V2 - SDP-24-06

# ROLESVILLE CROSSING

## AMENITY CENTER (OS 1006 & OS 1007) CONSTRUCTION DRAWINGS

PROJECT NUMBER: LEN2026  
SDP-24-06  
DATE: JULY 1, 2024

**SHEET**  
 AMENITY EXISTING  
 CONDITION  
**C1.01**

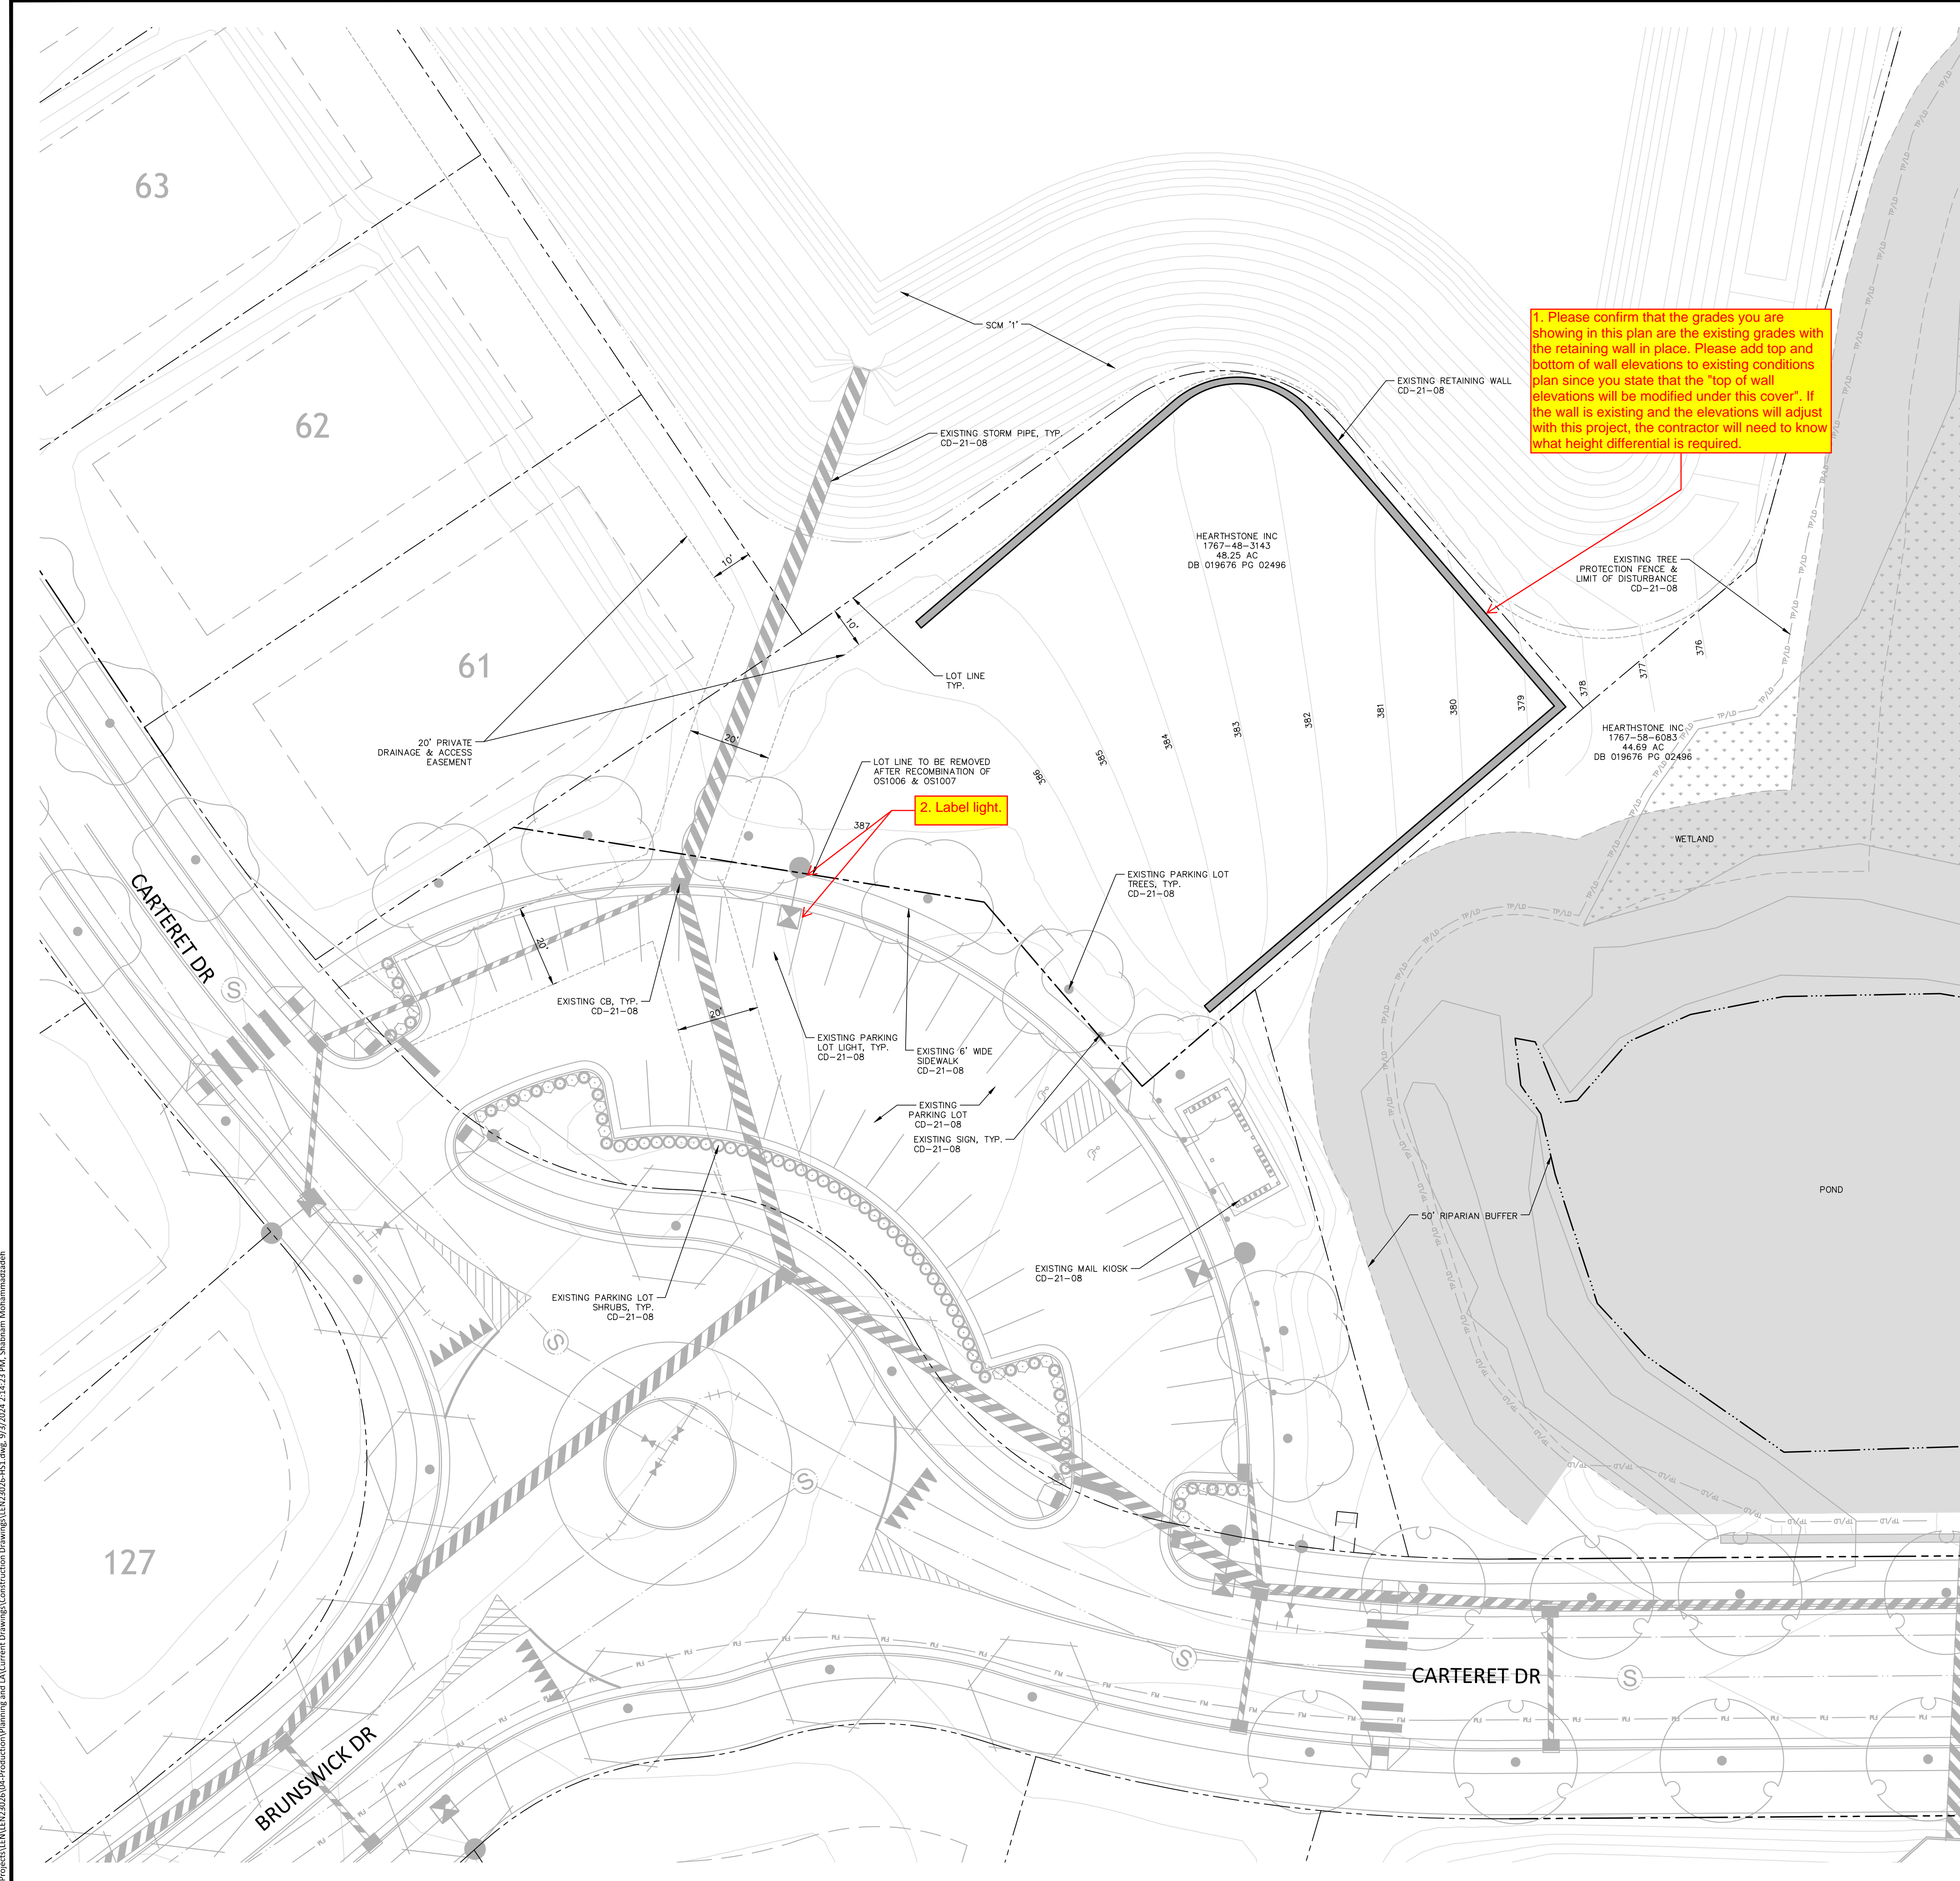
1. Please confirm that the grades you are showing in this plan are the existing grades with the retaining wall in place. Please add top and bottom of wall elevations to existing conditions plan since you state that the "top of wall elevations will be modified under this cover". If the wall is existing and the elevations will adjust with this project, the contractor will need to know what height differential is required.

2. Label light

**AMENITY HARDSCAPE PLAN**

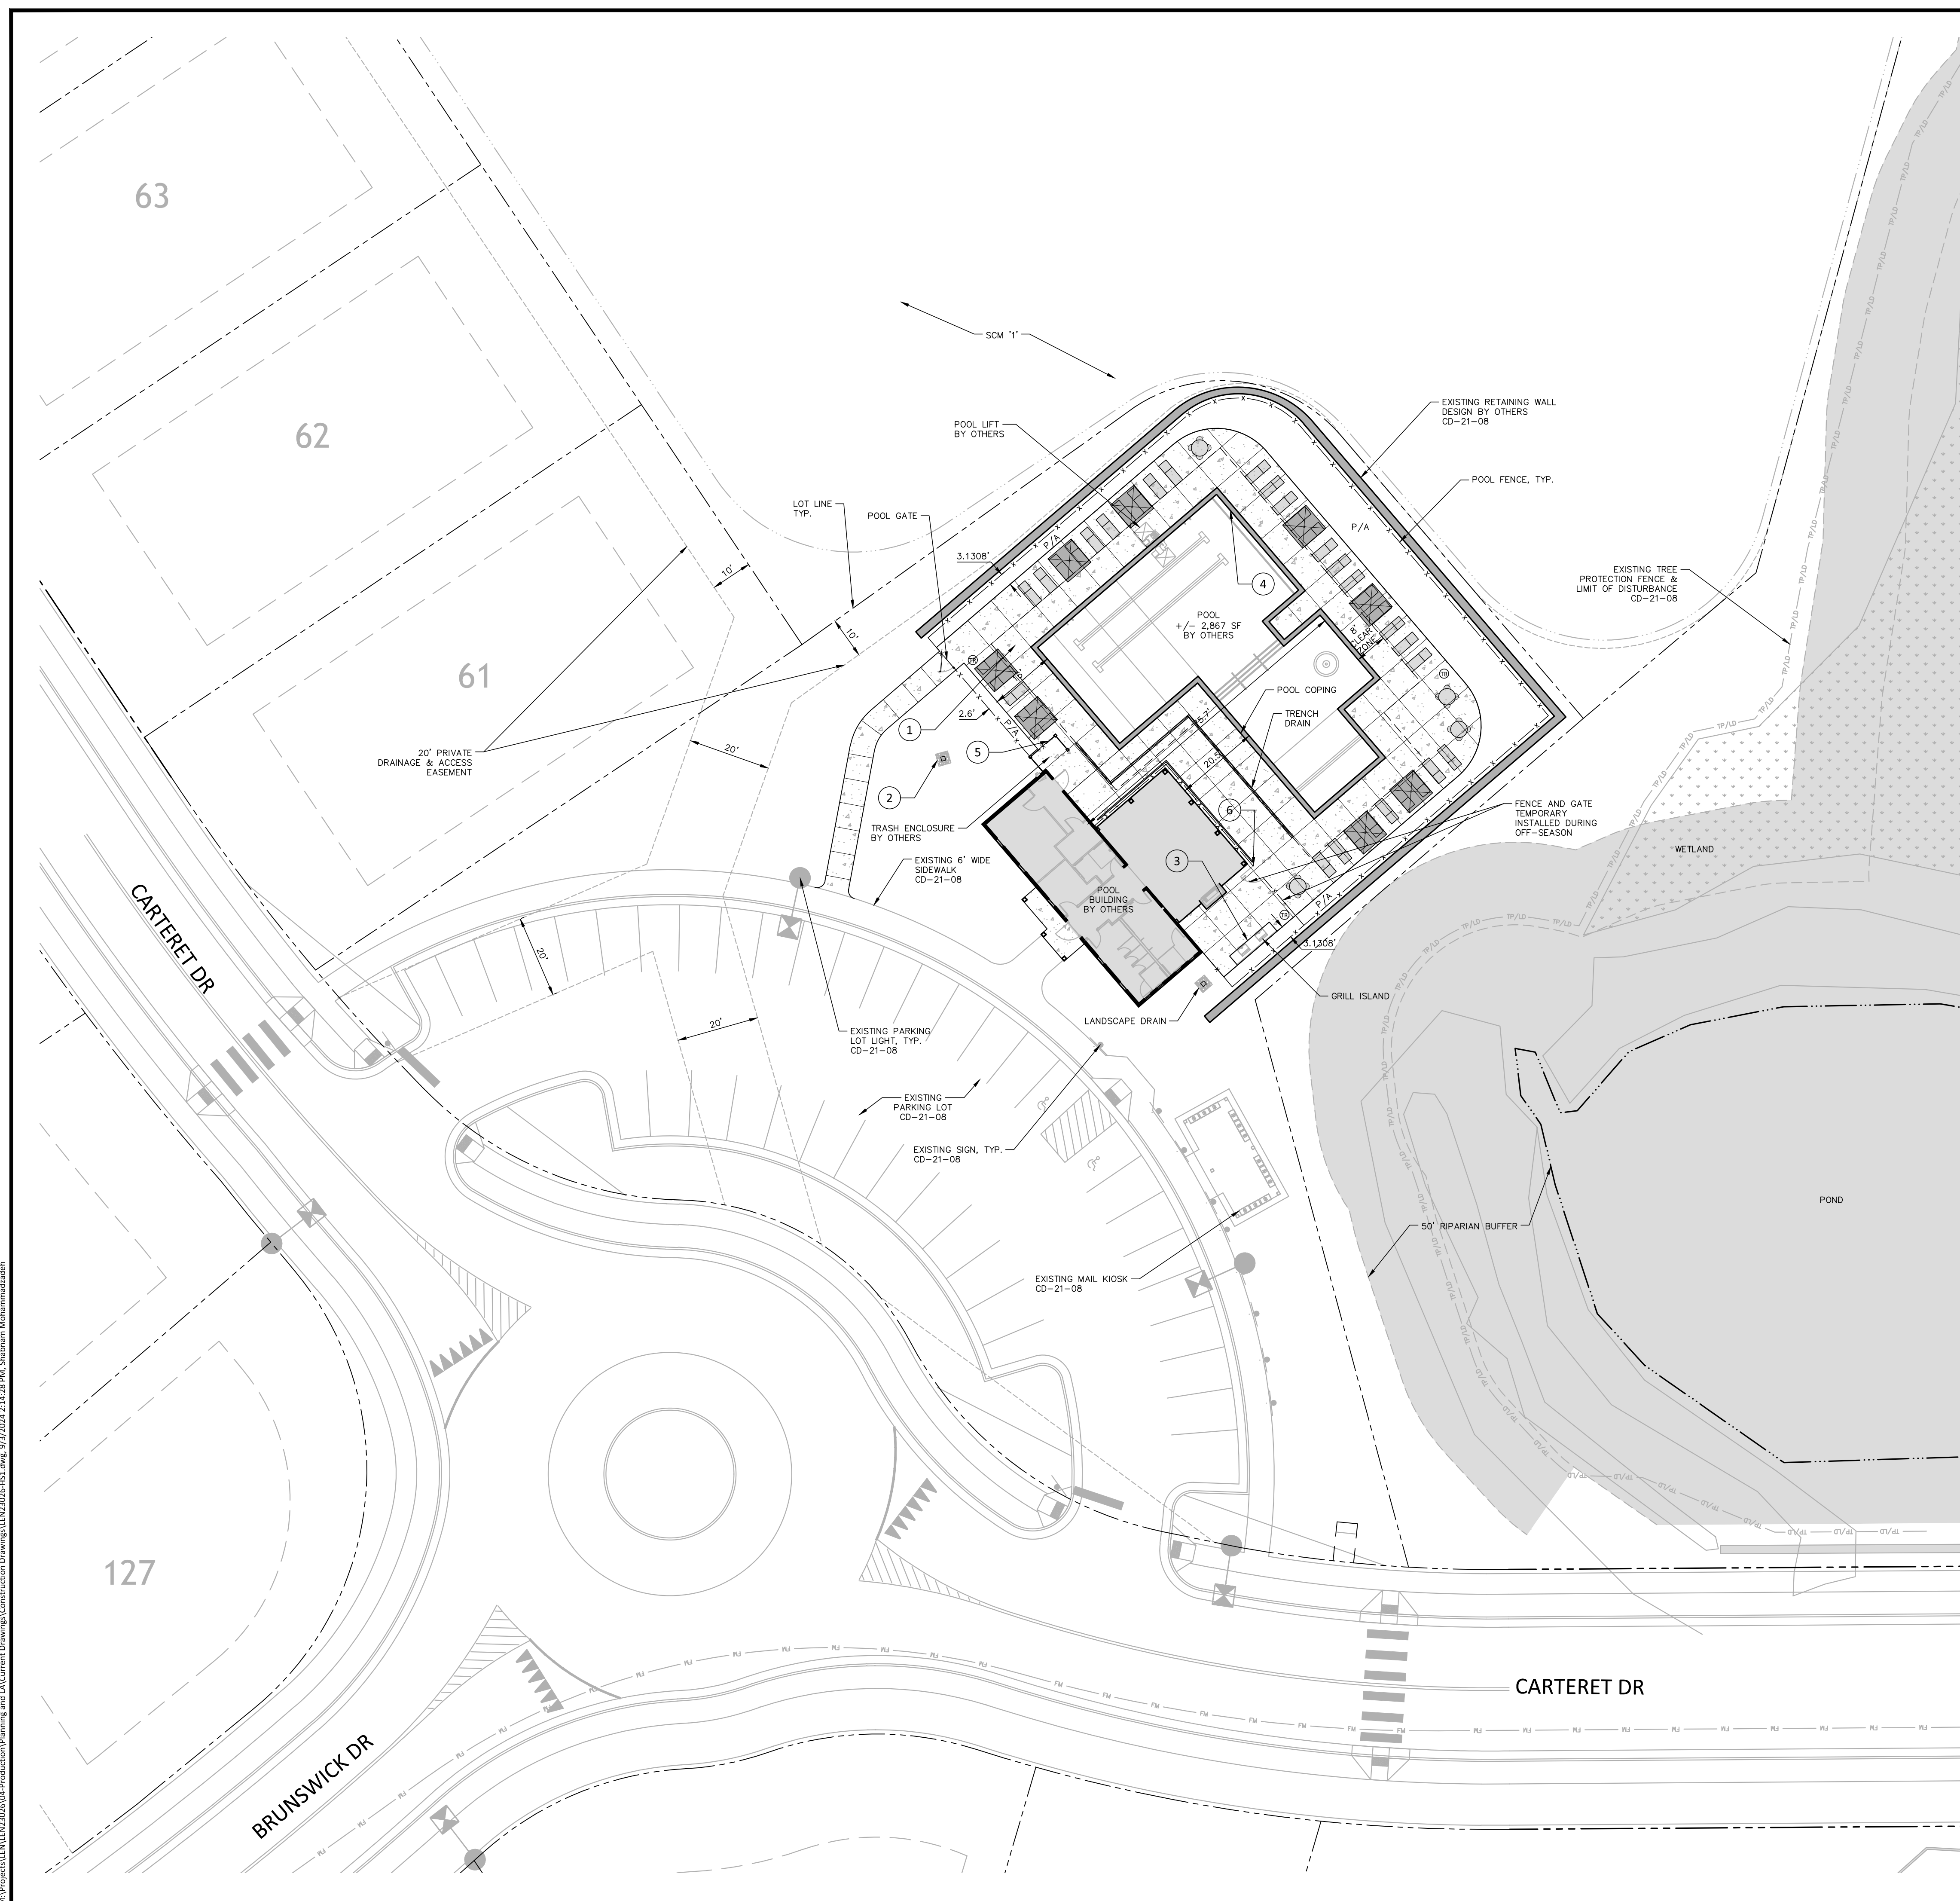
3. There should be one set of existing topo and it should match the existing conditions sheet. Please freeze any other "existing" topo on this sheet.

4. Fix overlap.

**SHEET**  
**AMENITY GRADING, DRAINAGE, AND EROSION CONTROL PLAN**  
**C3.00**

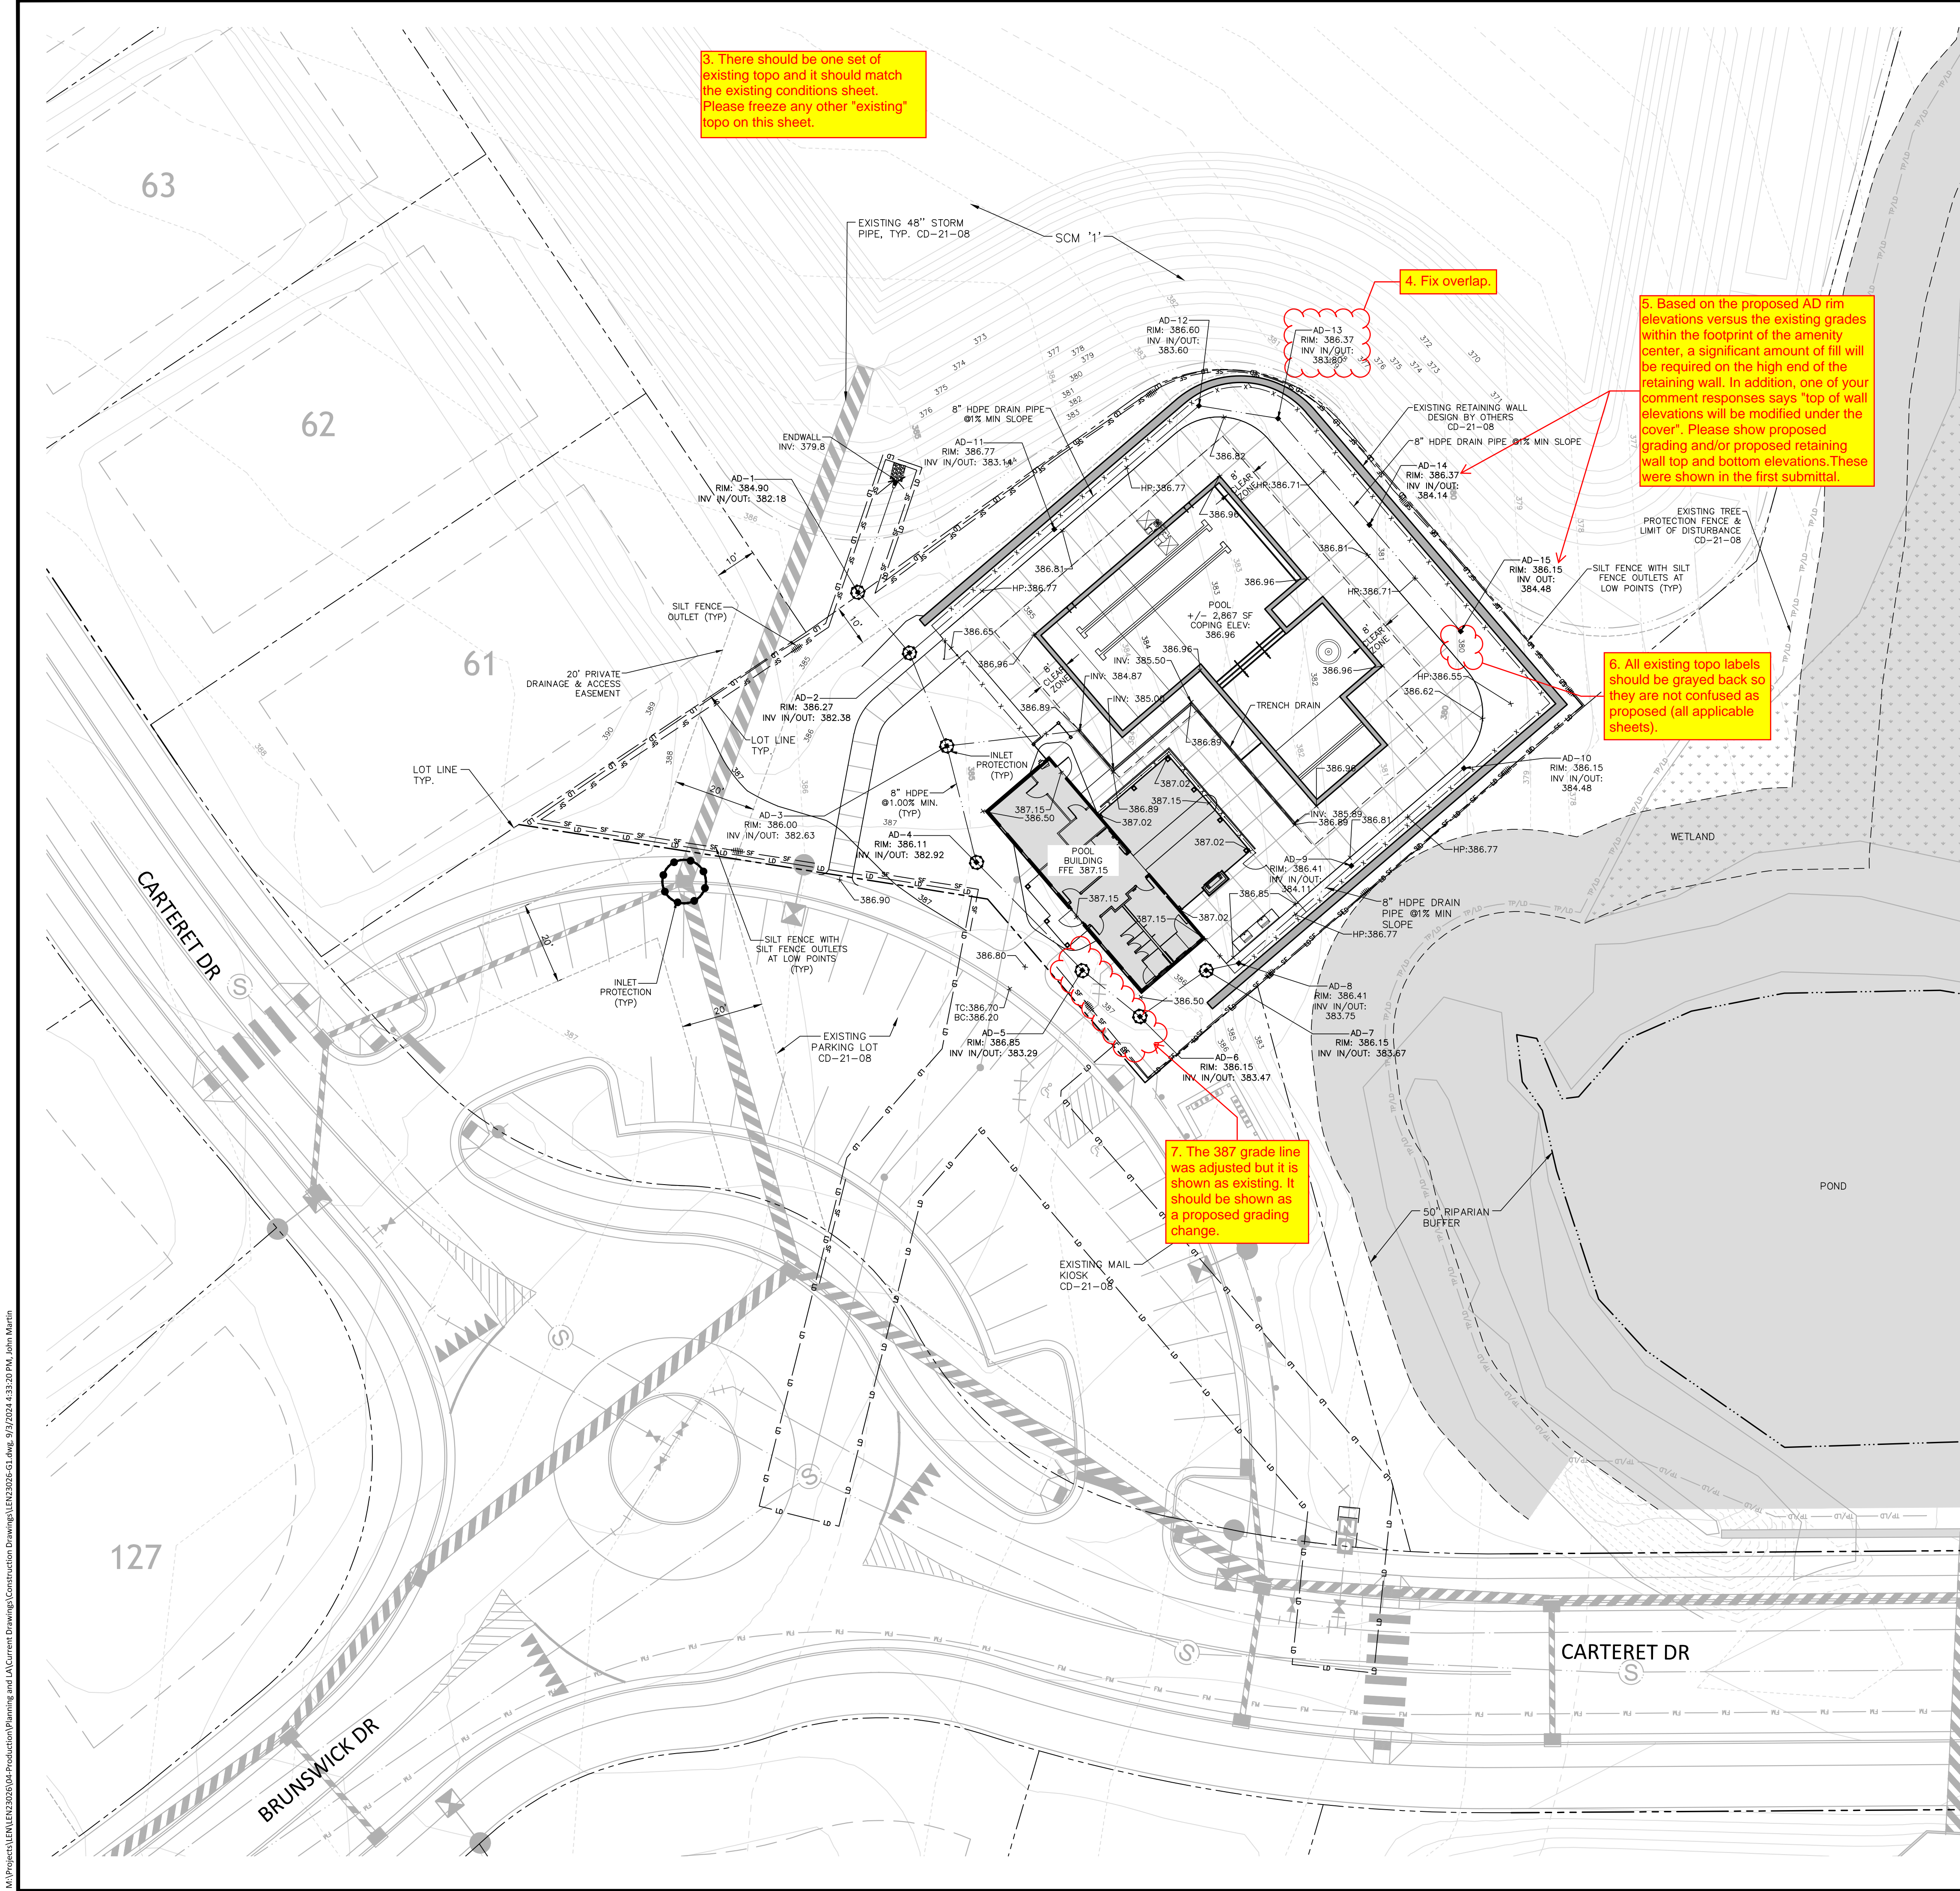
5. Based on the proposed AD rim elevations versus the existing grades within the footprint of the amenity center, a significant amount of fill will be required on the high end of the retaining wall. In addition, one of your comment responses says "top of wall elevations will be modified under the cover". Please show proposed grading and/or proposed retaining wall top and bottom elevations. These were shown in the first submittal.

6. All existing topo labels should be grayed back so they are not confused as proposed (all applicable sheets).

7. The 387 grade line was adjusted but it is shown as existing. It should be shown as a proposed grading change.
